INTEROFFICE MEMO

SUBJECT: REVIEW OF PLANS FOR RECONSTRUCTION AND RESTORATION OF FAIRMOUNT
PARK BANDSHELL, CITY LANDMARK #10

SUBJECT: CULTURAL HERITAGE BOARD REVIEW: FAIRMOUNT PARK BANDSHELL
RESTORATION.

EXTERIOR ELEVATIONS

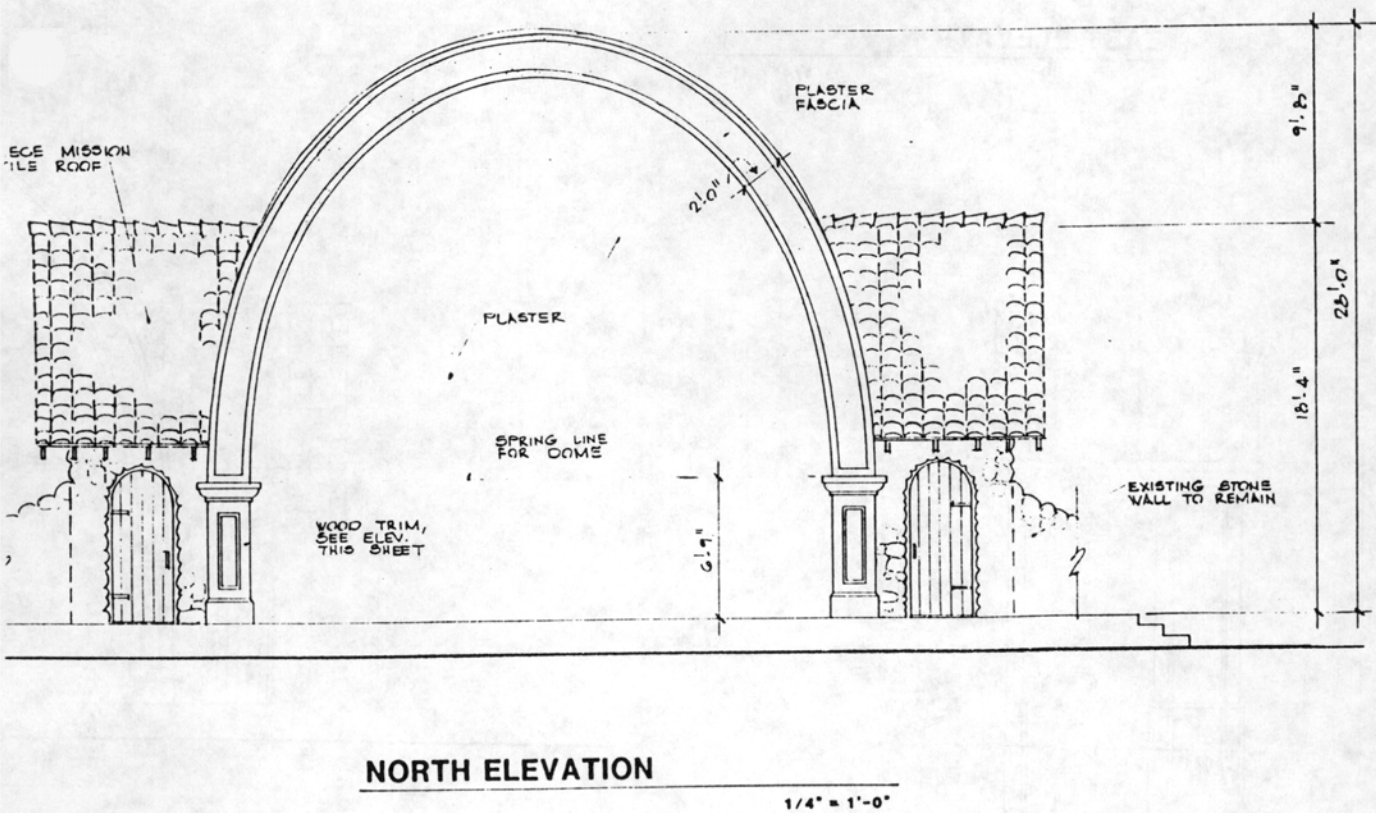
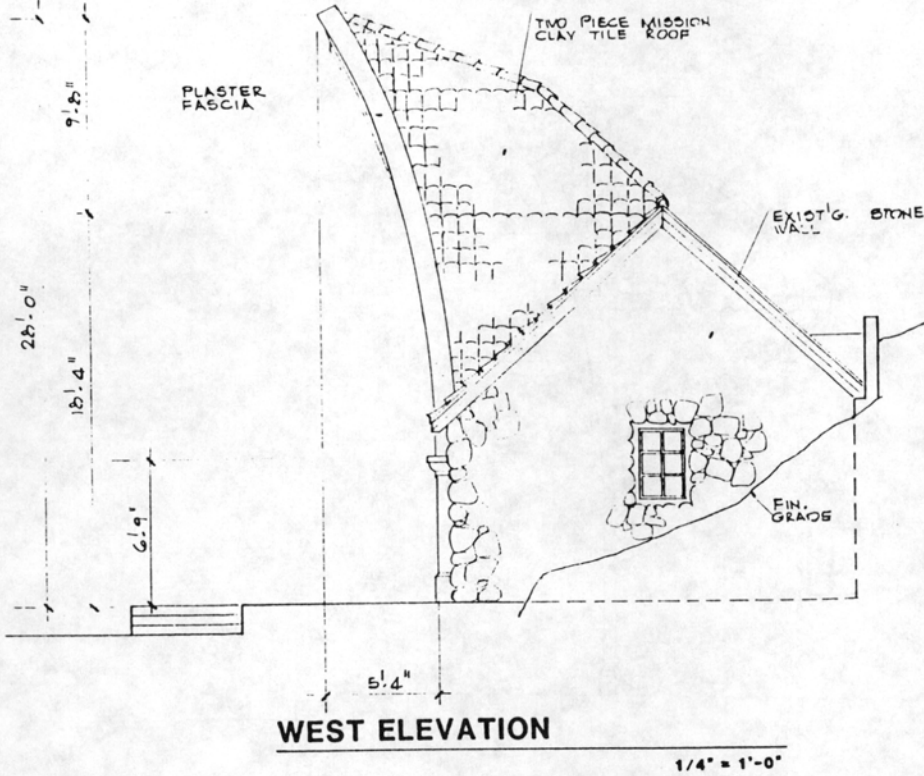
1. That the new steel columns and beams not be visible from the concave (exterior) surface of the shell wall.

2. That samples of the roof tile and composition roofing be submitted to CHB staff for approval prior to construction.

3. That color samples for painted exterior surfaces, wood and plaster, be submitted to CHB staff for approval.
